Environmental Planning Commission

Staff Report

Agenda Item Number: 6
Project #: PR-2021-005816
Case #: SI-2021-01684
VA#: 2021-00363
Hearing Date: November 18, 2021

Agent	Consensus Planning
Applicant	JB Holdings LLC/Take 5 Car Wash
Request	Site Plan Major Amendment/Variance
Legal Description	Lot 2-C of Lots 1,2-A, 2-B, 2-C, 2-D, 3,4,5, & 6 of Cottonwood Crossing Phase II being a replat of Tracts 14A/14B, Black Ranch
Location	Between Coors Bypass and Seven Bar Loop Road NW 10084 Coors Blvd NW
Size	Approximately 0.8 acres of a 10-acre site
Zoning	MX-L

Figure 4. Frontage of Lot 2-C showing easements limiting opportunities for landscaping.

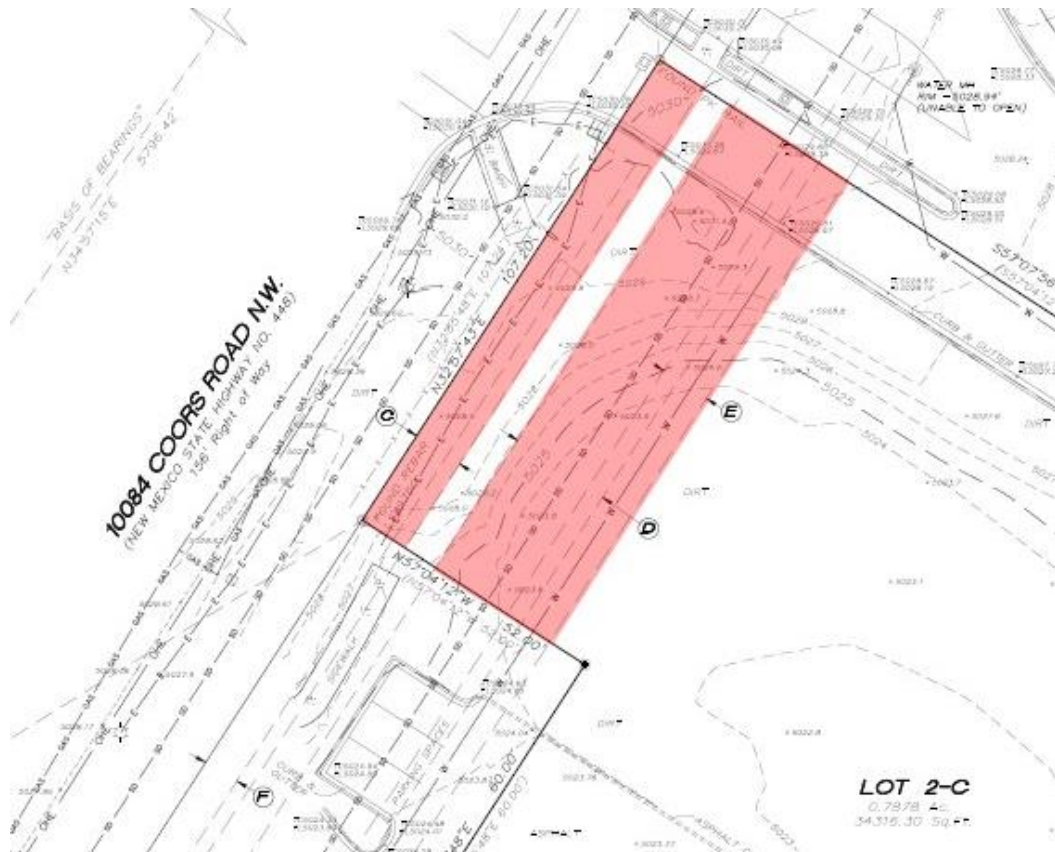
The second part of the request is for a Variance-EPC. The applicant requests that the 50% landscape coverage requirement for the setback along Coors Boulevard CPO-2 (IDO 3-4(C)(5)(c)) be reduced by 33%. There are several utility easements including water and sanitary sewer that run parallel to Coors Boulevard that prevent the applicant from planting trees and shrubs that would otherwise provide a significant amount of required coverage. The proposed landscape plan shows landscape coverage of 17% of the setback area.

1 TRASH ENCLOSURE
DD1.0 SCALE: 1/4" = 1'-0"

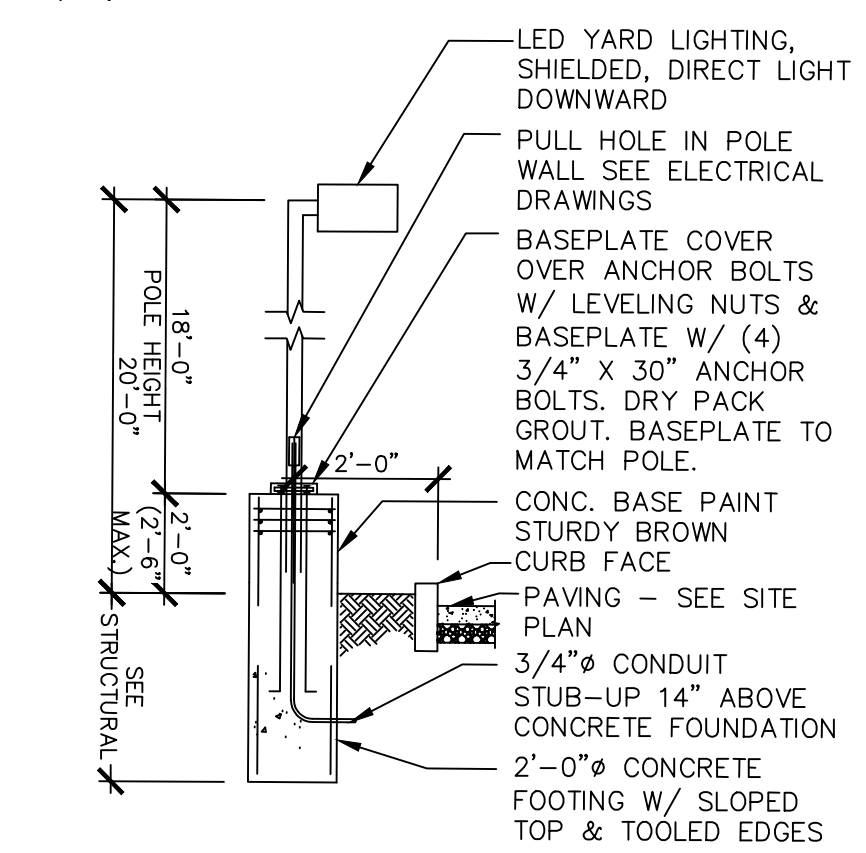
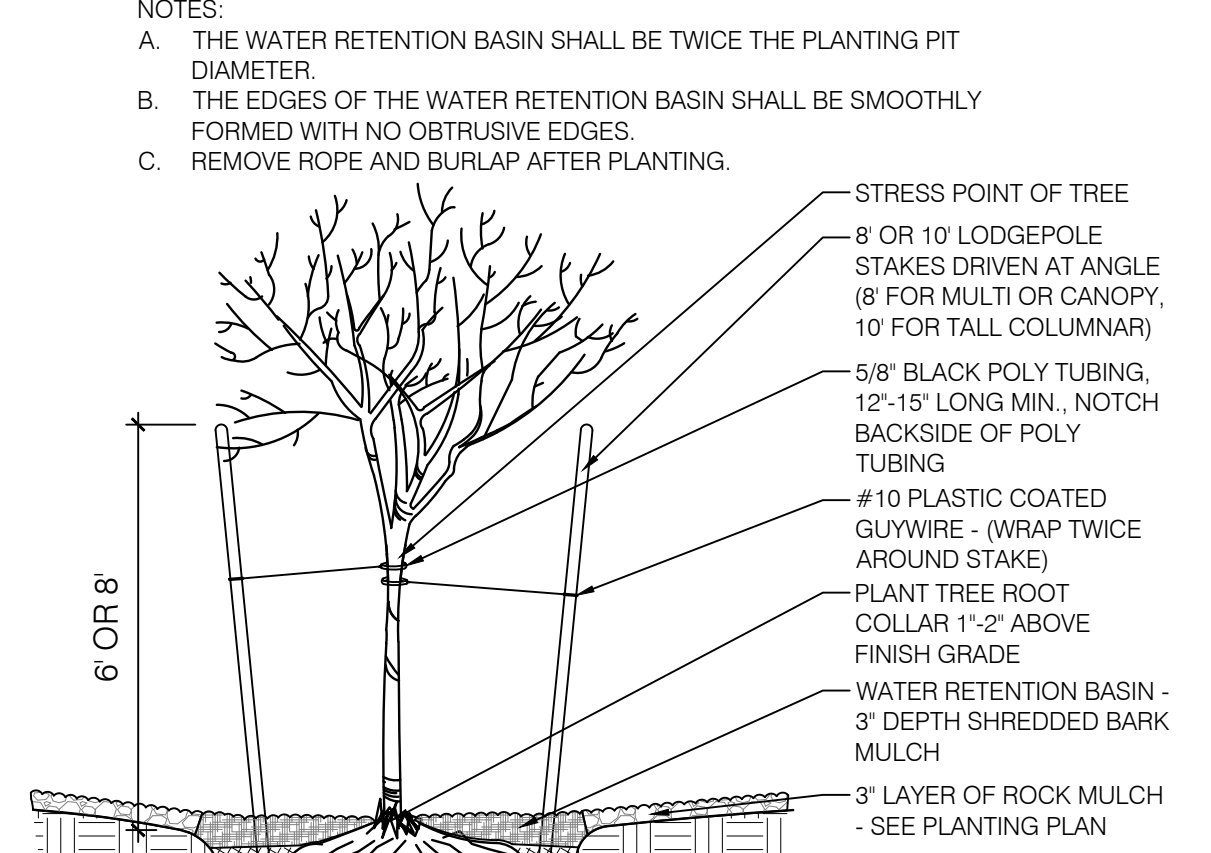
1. The Site Plan should not include detail drawings. Please move the Trash Enclosure and Light Pole Detail to a separate sheet and label it "Sheet Details".
2. The Site Plan and Landscape Plan are both labeled Sheet DD1. Please relabel one of the two plans.
3. The Site Plan does not include the roadway information or information on development nearby. Please refer to the Landscape Plan (also labeled Sheet DD1).
4. Clearly identify the property lines (refer to the Landscape Plan for the appropriate layout).
5. The Legend is missing on the Site Plan.
6. Relabel City of Albuquerque Site Plan Notes to General Sheet Notes.
7. Relabel Keyed Notes to Sheet Keyes Notes.

1 VIEW ANALYSIS
DD1.0 SCALE: 1" = 20'-0"

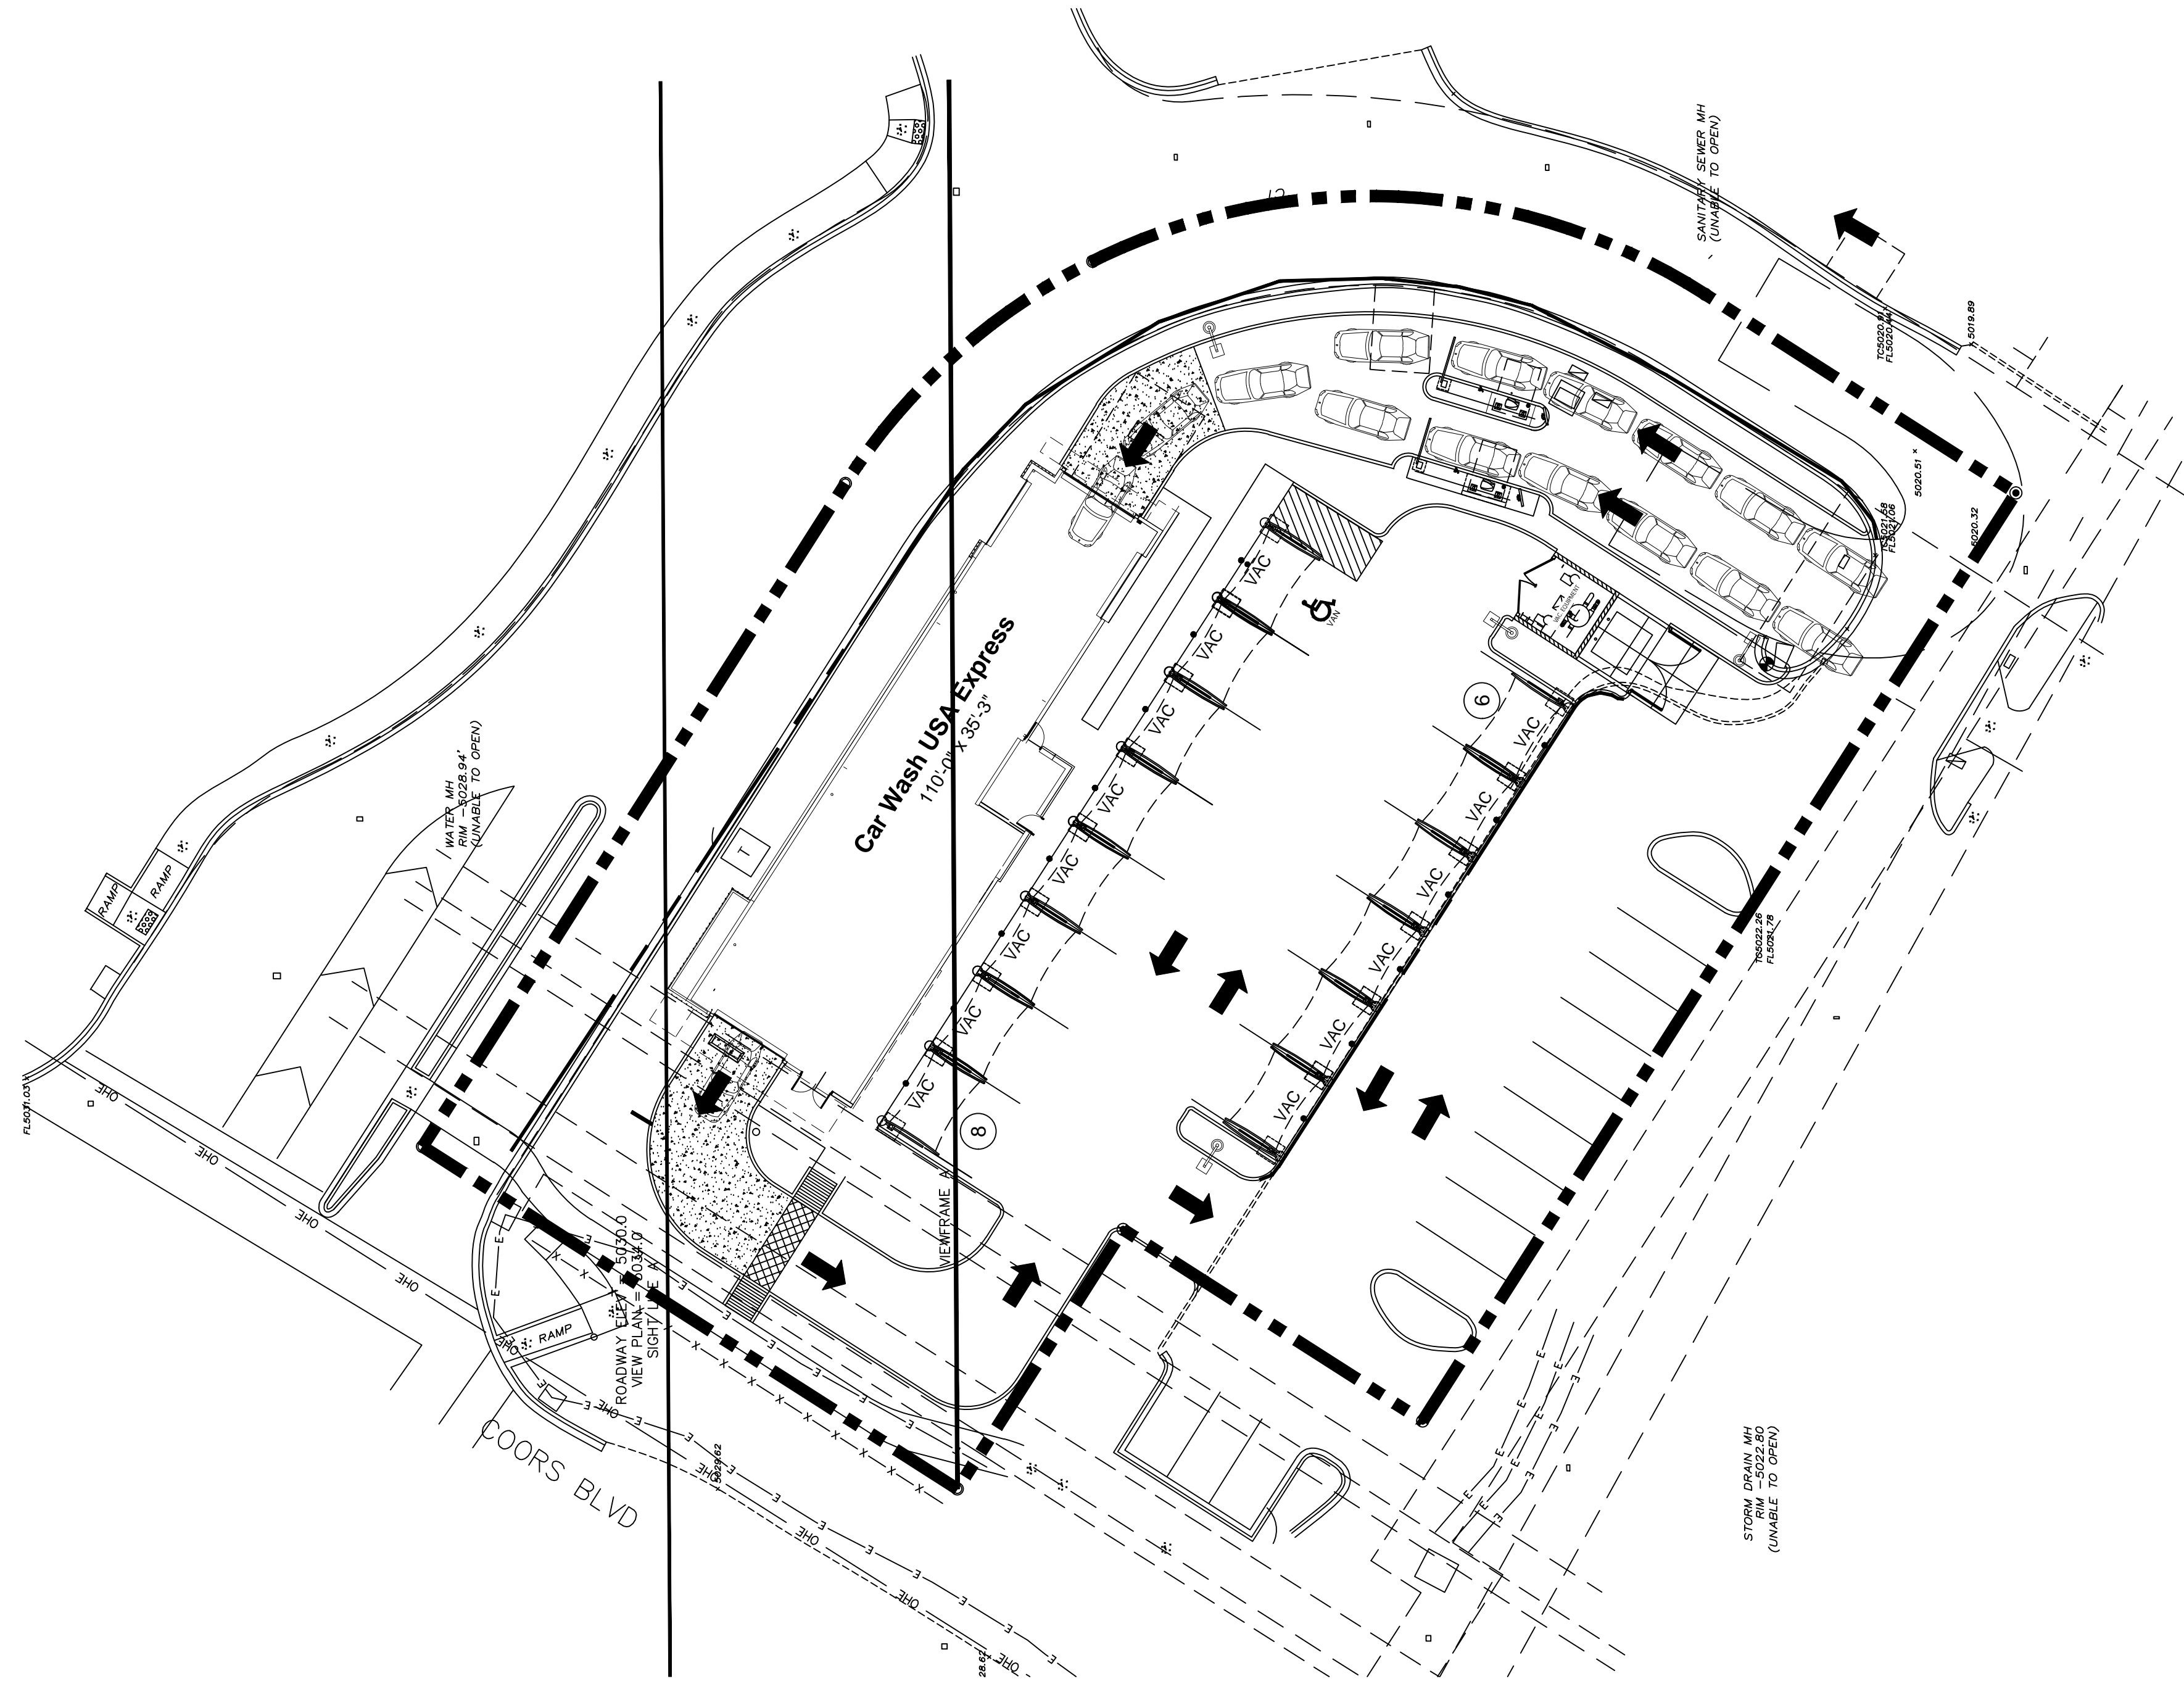
The elevation of Coors Boulevard Viewpoint is 5030' with the 4-foot view plane at 5034'. The finished floor elevation for the building is at 5027.50' and the highest part of the building (top of the branding tower) is at 5057.61'.

***Height above View Plane: 23.61'
Highest part of building: 30.11'
Maximum allowed height: 20'***

The elevation of Coors Boulevard is 5030' with the 4-foot view plane at 5034'. The elevations of finished floor of the proposed building would be 5027.50' and top of parapet at 5053.3'

Height above View Plane: 19.3'
Total Building Height: 25.8'
Maximum amount permissible is 20'
